**METROPOLITAN GOVERNMENT OF NASHVILLE AND DAVIDSON COUNTY**

**STAFF RECOMMENDATION**  
**3531 Central Avenue**  
**August 19, 2020**

**Application:** New Construction--Addition  
**District:** Richland-West End Neighborhood Conservation Zoning Overlay  
**Council District:** 24  
**Base Zoning:** RS7.5  
**Map and Parcel Number:** 10405039000  
**Applicant:** Whit Smith  
**Project Lead:** Paul Hoffman; [paul.hoffman@nashville.gov](mailto:paul.hoffman@nashville.gov)

<p><b>Description of Project:</b> This application is for construction of a rear addition to the contributing building.</p> <p><b>Recommendation Summary:</b> Staff recommends approval of the application with the conditions:</p> <ol style="list-style-type: none"> <li>1. Staff approve the final details, dimensions and materials of windows and doors prior to purchase and installation;</li> <li>2. Lap siding shall have a five inch (5”) reveal or less;</li> <li>3. The HVAC shall be located behind the house or on either side, beyond the mid-point of the house; and</li> <li>4. Staff approve new brick for color, dimensions and texture.</li> </ol> <p>Staff finds that the proposed new construction meets section II.B.1 for New

Figure 2. Sanborn map c. 1957 indicates the original two-story open rear porch on the building.

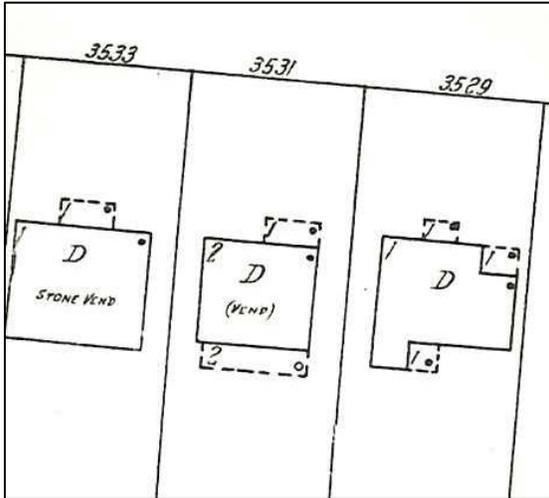
Demolition: A rear addition is proposed to be removed. Originally it was an open two-story porch and was enclosed at an unknown date. Staff finds removal to be appropriate since its been so greatly altered and because of its minimal visibility. No existing window and door openings are proposed to be altered. Staff finds that the proposed partial demolition meets Section III.B.2 for appropriate demolition and does not meet section III.B.1 for inappropriate demolition.

**2** SITE PLAN  
SCALE: 1" = 10'

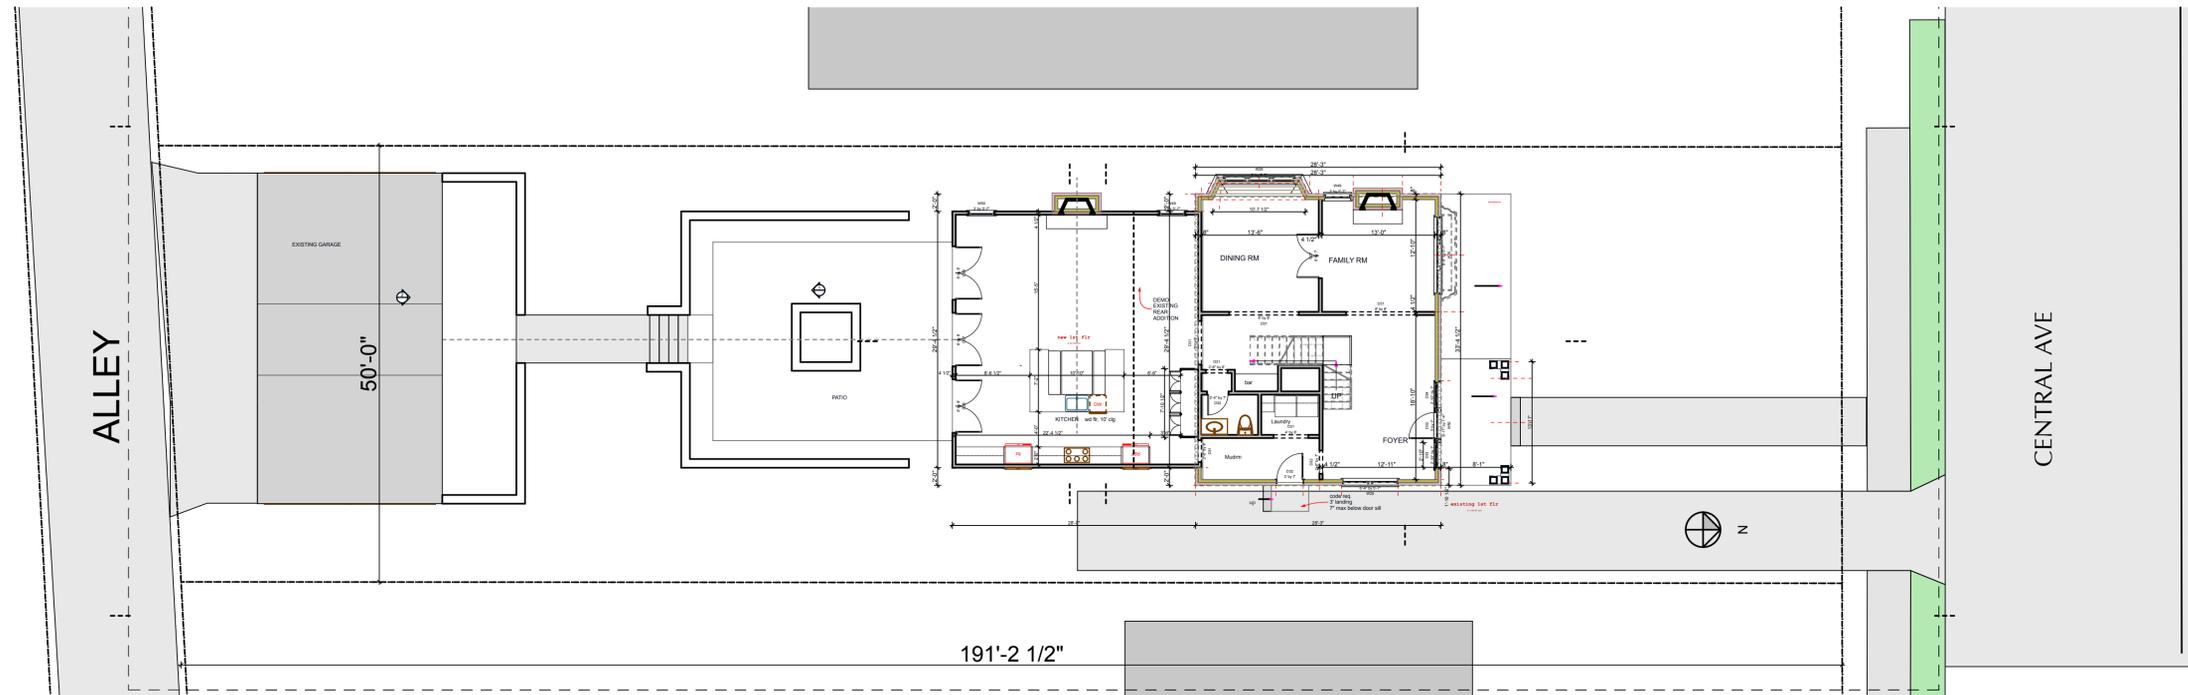
Setback & Rhythm of Spacing: The proposed setbacks are seven feet six inches (7' 6") on the right side, and thirteen feet (13') on the left, meeting the setback requirements of bulk zoning of five feet (5'). The rear of the addition will be approximately ninety-three feet (93') from the rear property line, and sixty feet (60') from the existing outbuilding, meeting the required twenty feet (20') from both rear setback and from the outbuilding. The project meets section II.B.1.c.

Appurtenances & Utilities: No changes to the site’s appurtenances were indicated on the drawings. The location of the HVAC and other utilities was also not noted. Staff asks that the HVAC be located on the rear façade, or on a side façade beyond the midpoint of the house. The project meets section II.B.1. i.

ELEVATIONS

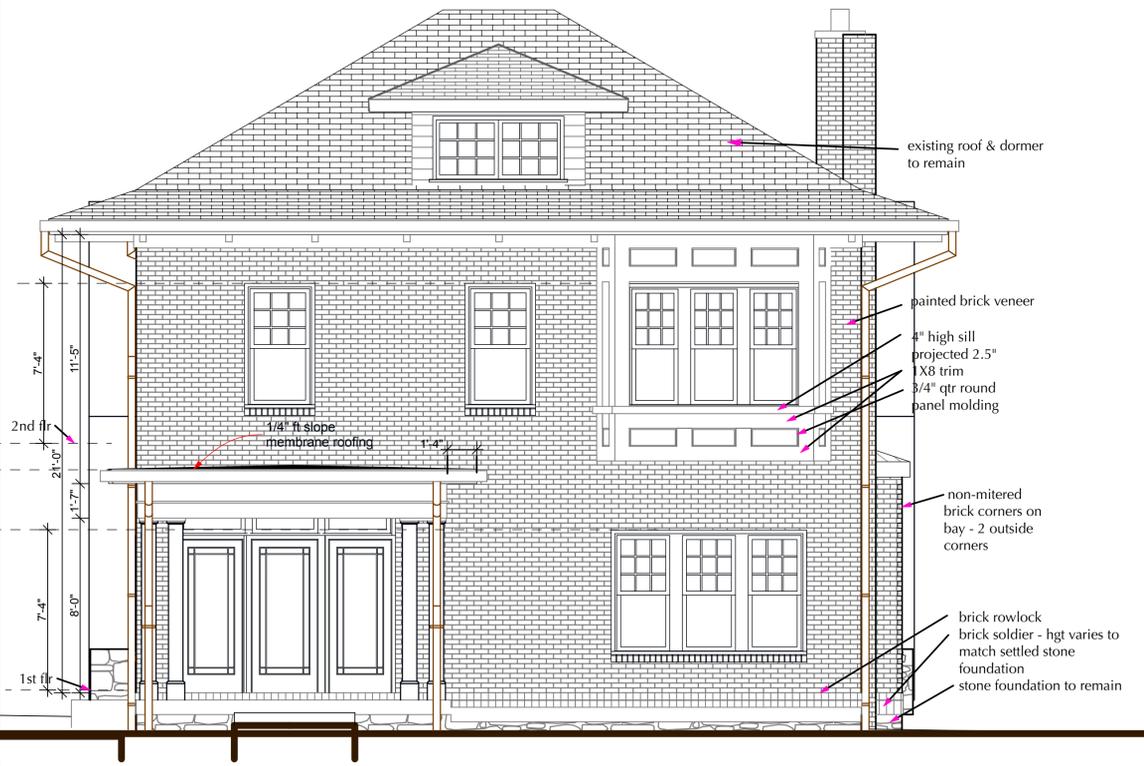
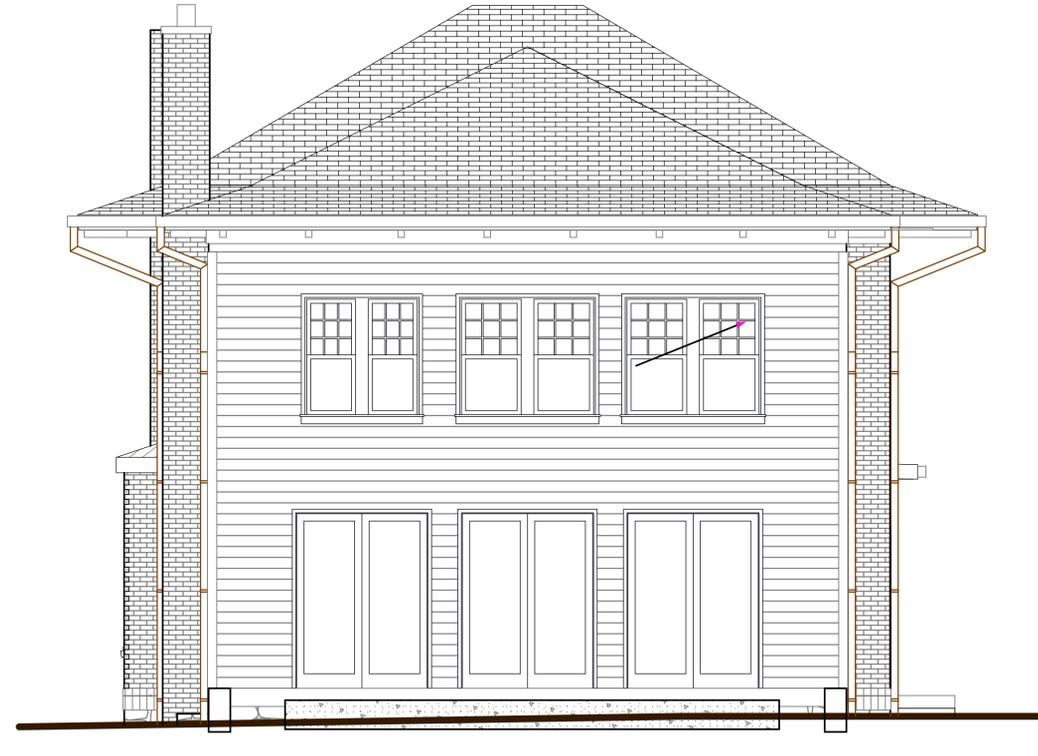
Height & Scale: The proposed addition is two stories, matching the scale of the historic home. The ridge height will be approximately two feet (2') lower than the ridge of the historic roof. The eave height (22') and foundation height (16") will match those of the house. The new footprint is an additional eight hundred and twelve square feet (812 sq. ft.), which is less than the existing footprint of the house, which is one thousand, one hundred and seventy-six square feet (1,176 sq. ft.). Staff finds that the massing of the project is appropriate and meets section II.B.1.a.and b.

Design, Location & Removability: The proposed rear addition ties into the historic roof approximately two feet (2') below the ridge of the house. The location of the addition at the rear of the existing building is in accordance with the design guidelines. The addition's change in materials, inset, and separate roof form help to distinguish it from the historic house and read as an addition. The location and manner of connection to the roof would allow the addition to be removed in the future, without changing the historic character of the house. The project meets section II.B.2.a, II.B.2.d, and II.B.2.e.

The applicant indicated to staff that the lap siding would be a six-inch (6") reveal; the design guidelines specify no greater than five inches (5") reveal. Staff recommends the reveal be no greater than five inches (5"). The masonry for the chimney will be reused from portions of brick removed from the rear wall; if additional brick is required, staff

recommends having final approval of a brick sample. With the conditions that the lap siding will not exceed a five-inch (5”) reveal, and with staff’s final review of windows, doors, and brick, the project meets section II.B.1.d.

Roof form: The addition’s roof form is a hipped roof which is an appropriate roof form historically and does not contrast with the roof form of the historic home. The primary roof pitch is 5/12. The proposed roof form and slope is compatible with this residence and nearby historic roofs. The addition does not include any dormers or skylights, but a masonry chimney will be on the addition’s right side. The project meets section II.B.1.e.

Proportion and Rhythm of Openings: No changes to the window and door openings on the existing house were indicated on the plans. The windows on the proposed addition are generally twice as tall as they are wide, thereby meeting the historic proportions of openings. There are no large expanses of wall space without a window or door opening. Two window openings on the addition’s left side are proposed to be shuttered; this is in an area of minimal visibility on the new construction, and this has been approved previously; therefore staff finds these window openings appropriate in this case. Staff finds the project’s proportion and rhythm of openings to meet Section II.B.1.g.

1. Staff approve the final details, dimensions and materials of windows and doors prior to purchase and installation;
2. Lap siding shall have a five inch (5”) reveal or less;
3. The HVAC shall be located behind the house or on either side, beyond the mid-point of the house; and
4. Staff approve new brick for color, dimensions and texture.
